Addendum 136 – UN Regulation No. 137

Revision 1 - Amendment 4

02 series of amendments – Date of entry into force: 9 June 2021

Uniform provisions concerning the approval of passenger cars in the event of a frontal collision with focus on the restraint system

Figure 3
Jointed Test Finger

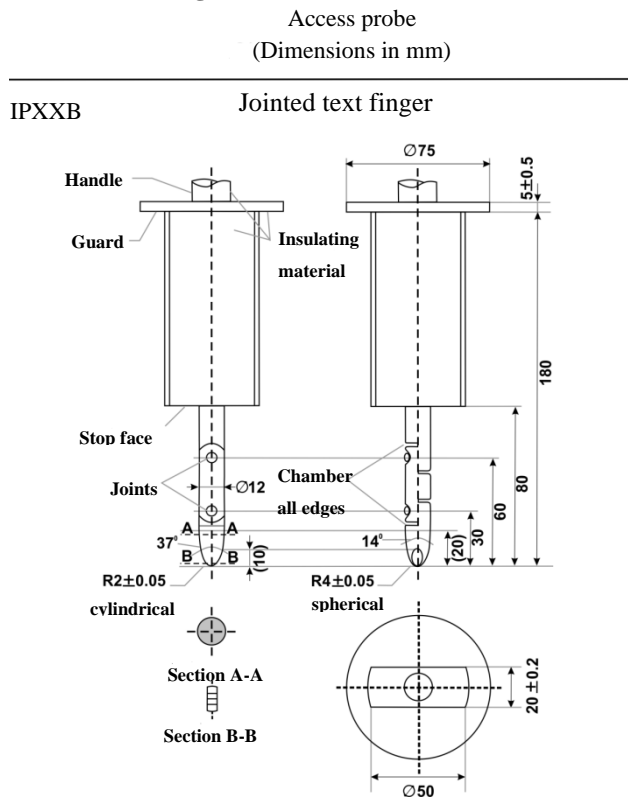
The jointed test finger described in Figure 3 shall be inserted into any gaps or openings of the physical protection with a test force of $10 \text{ N} \pm 10$ per cent for electrical safety assessment. If partial or full penetration into the physical protection by the jointed test finger occurs, the jointed test finger shall be placed in every position as specified below.

Starting from the straight position, both joints of the test finger shall be rotated progressively through an angle of up to 90 degrees with respect to the axis of the adjoining section of the finger and shall be placed in every possible position.

The requirements of paragraph 5.2.8.1.3. of this Regulation are met if the jointed test finger described in Figure 3, is unable to contact high voltage live parts.

Figure 4

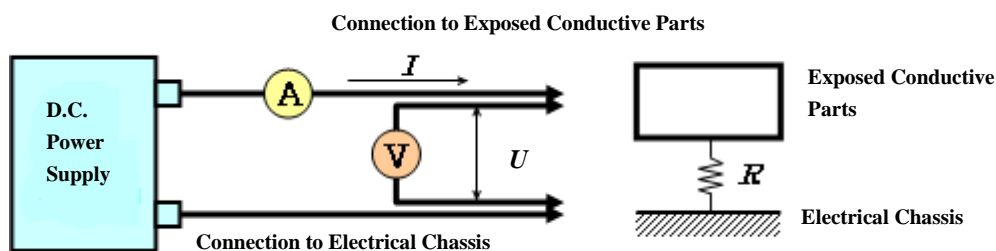
The DC power supply, voltmeter and ammeter are connected to the measuring points (Typically, electrical chassis and electro conductive enclosure/electrical protection barrier).

The voltage of the DC power supply is adjusted so that the current flow becomes at least 0.2 A.

The current "I" and the voltage "U" are measured.

The resistance "R" is calculated according to the following formula:

$$R = U / I$$

The resistance R shall be less than 0.1 Ω.

Note: If lead wires are used for voltage and current measurement, each lead wire shall be independently connected to the electrical protection barrier/enclosure/electrical chassis. Terminal can be common for voltage measurement and current measurement.

Example of the test method using DC power supply, voltmeter and ammeter is shown below.

Figure 5
Measurement of U_1'

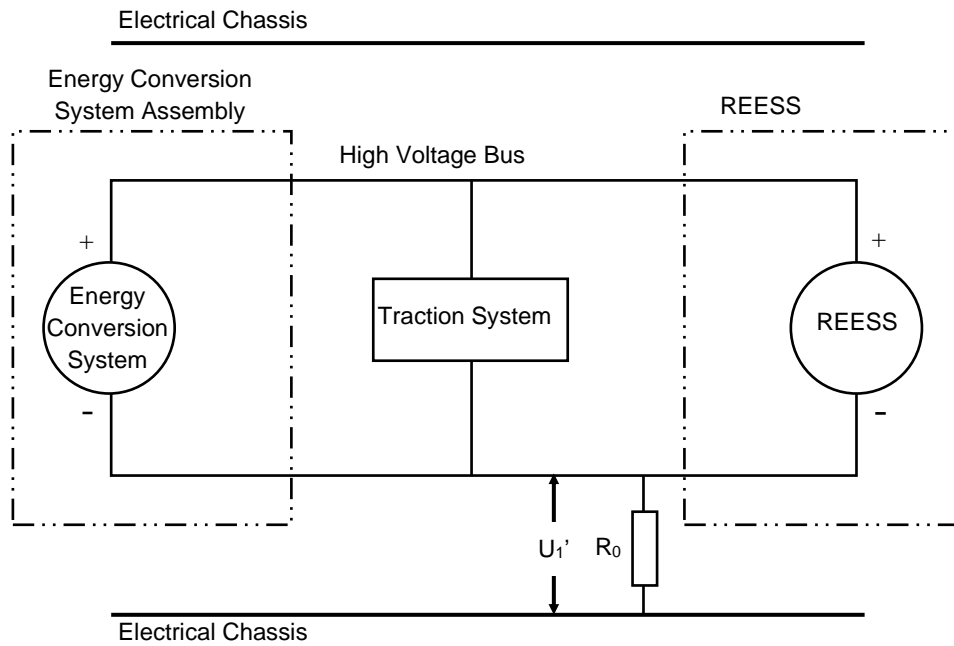
If U_1 is greater than or equal to U_2 , a standard known resistance (R_o) is inserted between the negative side of the high voltage bus and the electrical chassis. With R_o installed, the voltage (U_1') between the negative side of the high voltage bus and the electrical chassis is measured (see Figure 5).

The electrical isolation (R_i) is calculated according to the following formula:

$$R_i = R_o * U_b * (1/U_1' - 1/U_1)$$

Figure 6
 Measurement of U_2'

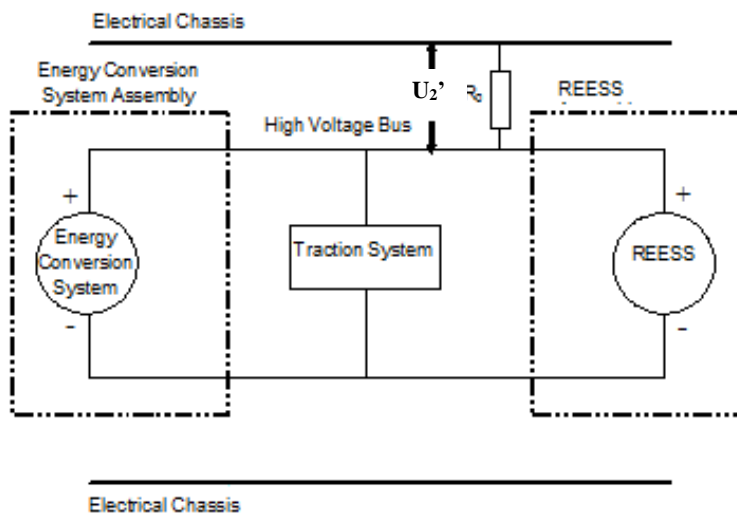
If U_2 is greater than U_1 , insert a standard known resistance (R_o) between the positive side of the high voltage bus and the electrical chassis. With R_o installed, measure the voltage (U_2') between the positive side of the high voltage bus and the electrical chassis (see Figure 6 below). The electrical isolation (R_i) is calculated according to the following formula:

$$R_i = R_o * U_b * (1/U_2' - 1/U_2)$$
